HUNTSVILLE UTILITIES SOUTHEAST WATER TREATMENT PLANT

To: All Plan Holders

From: Tetra Tech

Date: December 10, 2014

D-2303

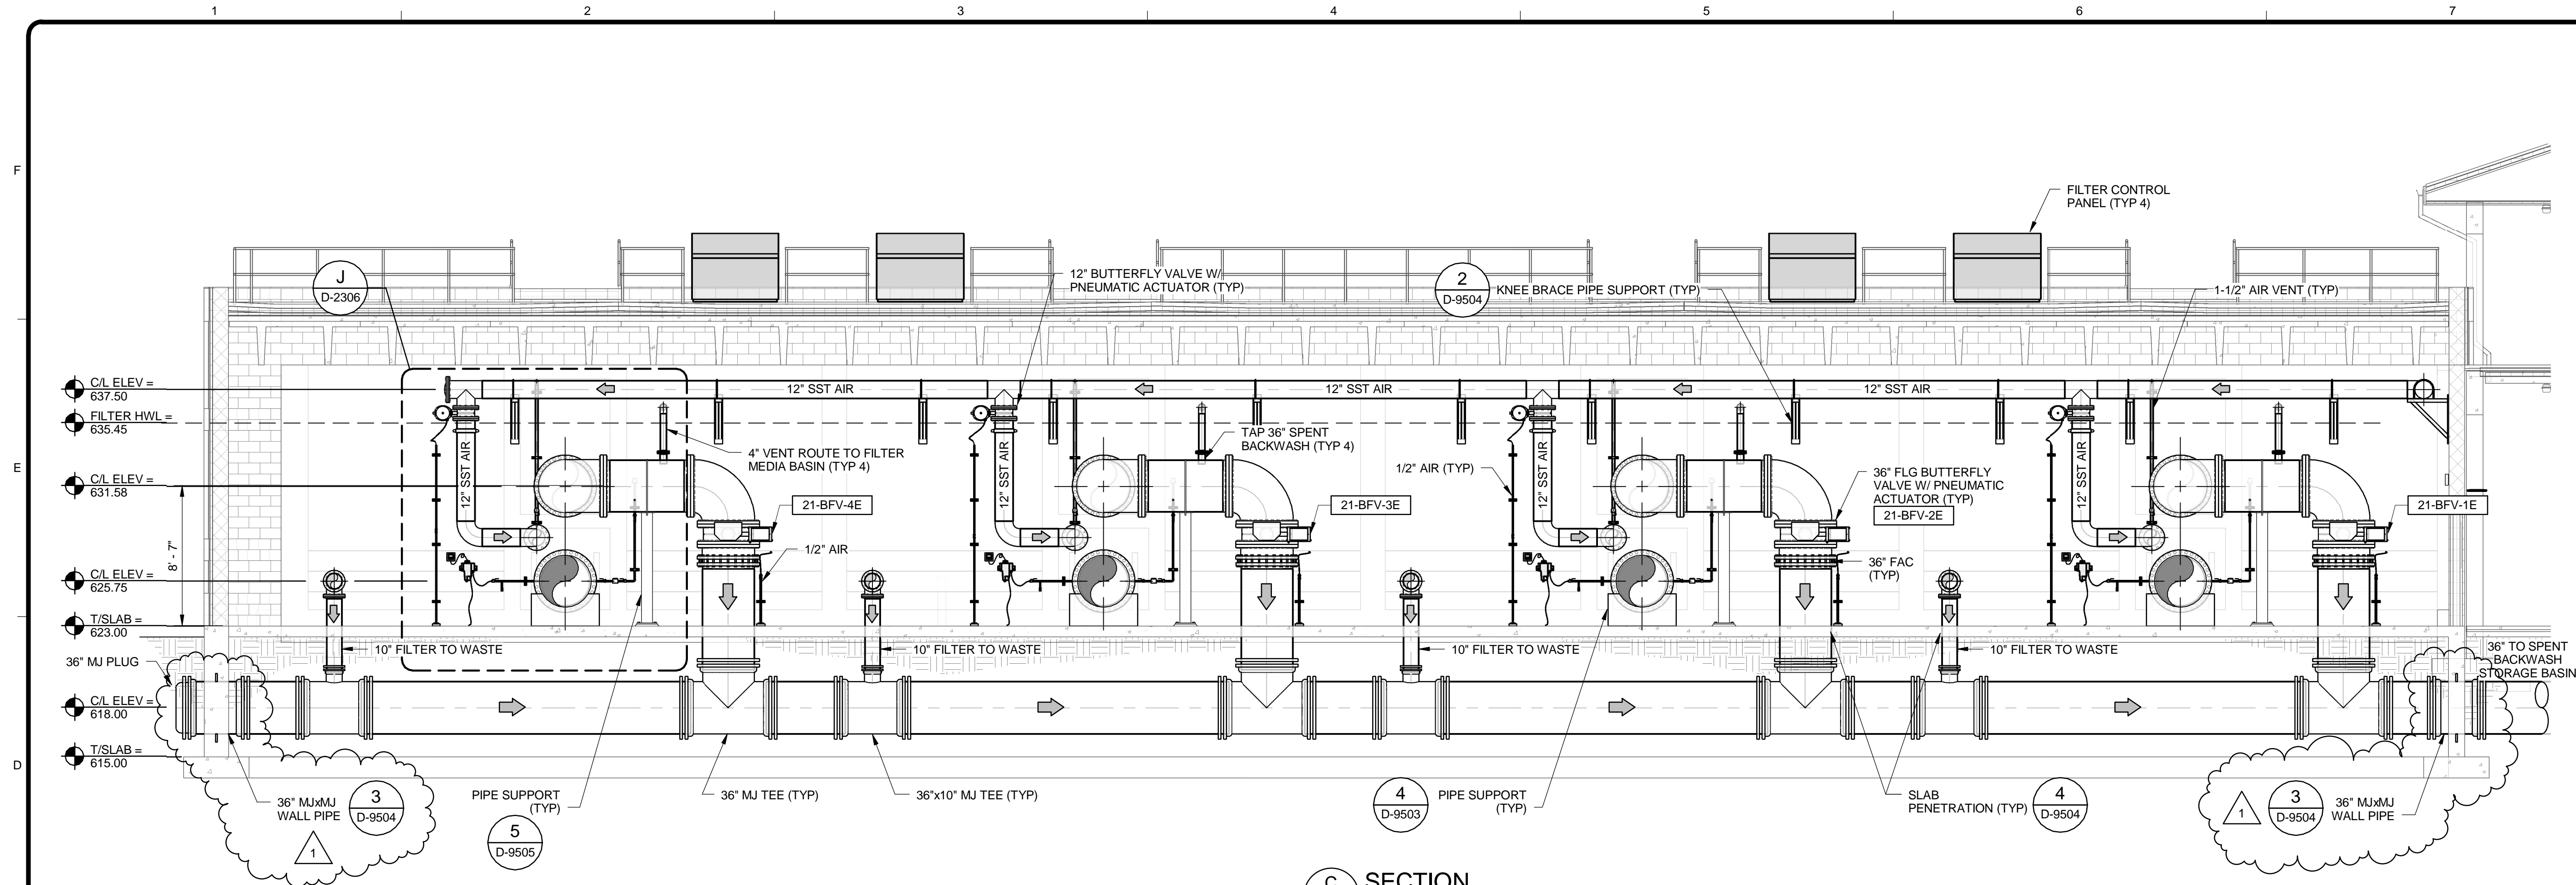
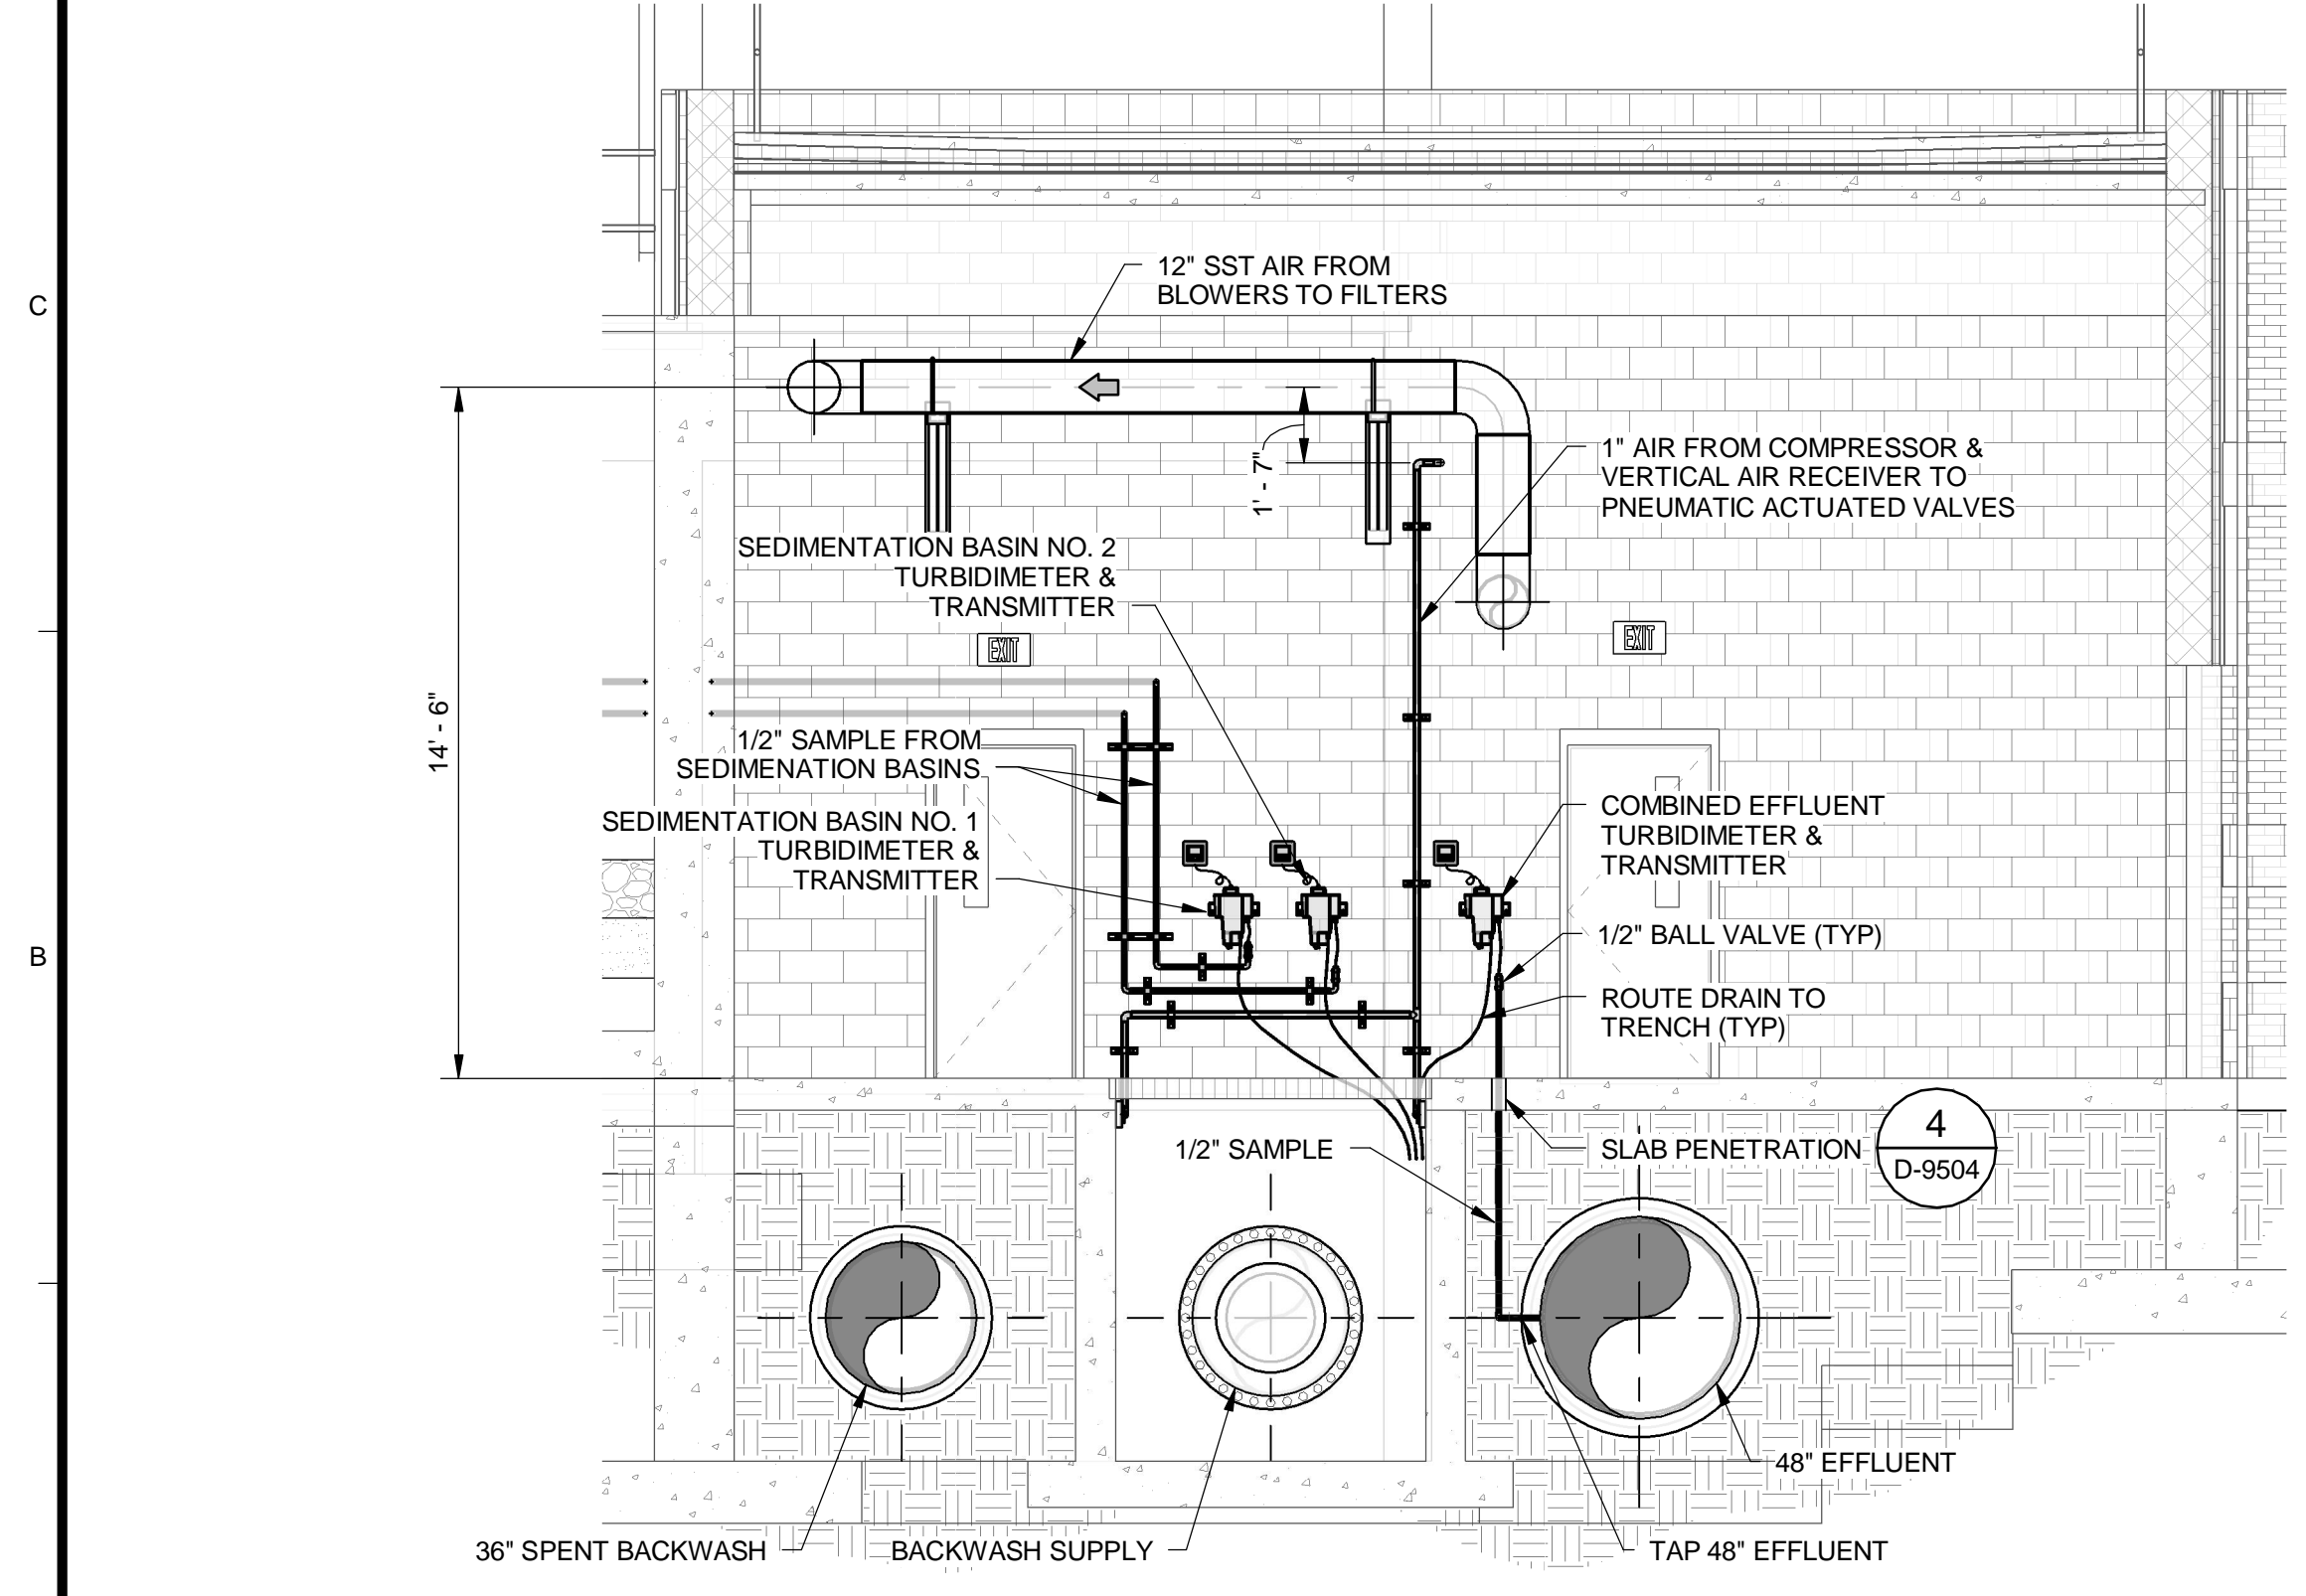
- Item No. 25: **Sheets D-2303 and D-2304.** Replace the existing sheets with revised sheets (attached) noting the requirements for wall pipes with wall collars at each end of the pipe gallery.

D-3301

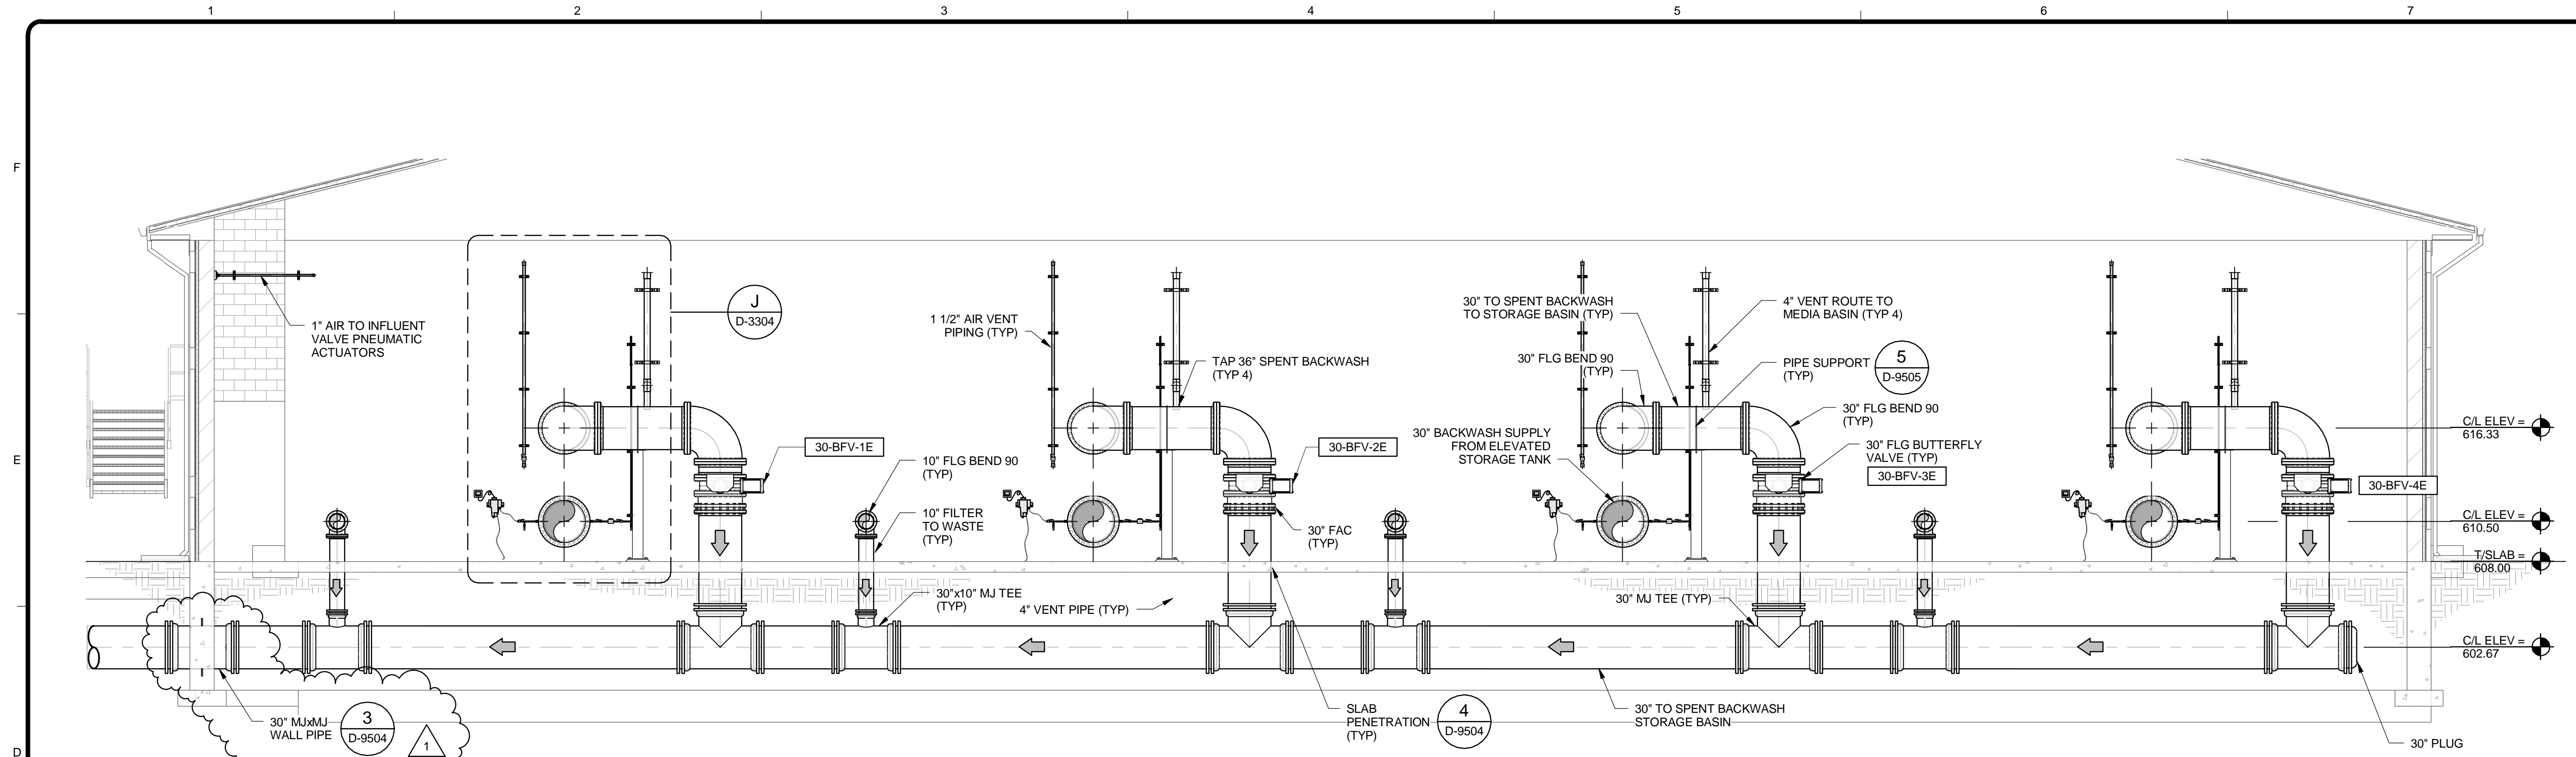
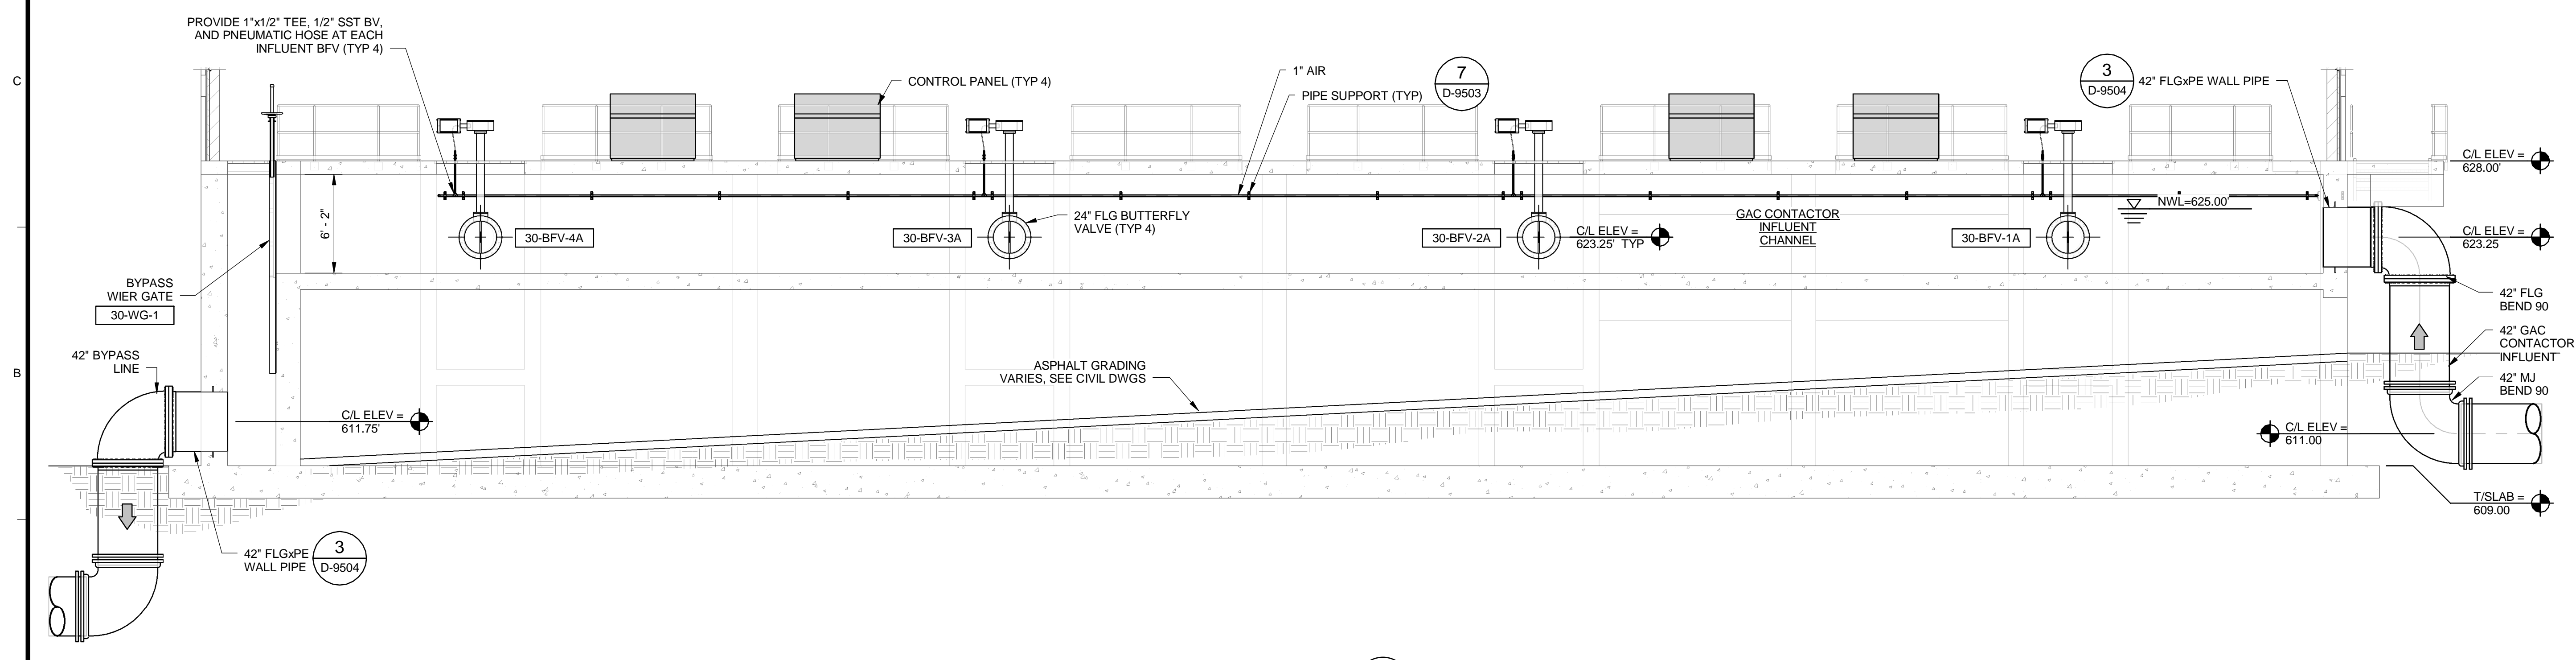
- Item No. 26: **Sheets D-3301 and D-3302.** Replace the existing sheets with revised sheets (attached) noting the requirements for wall pipes with wall collars at each end of the pipe gallery.
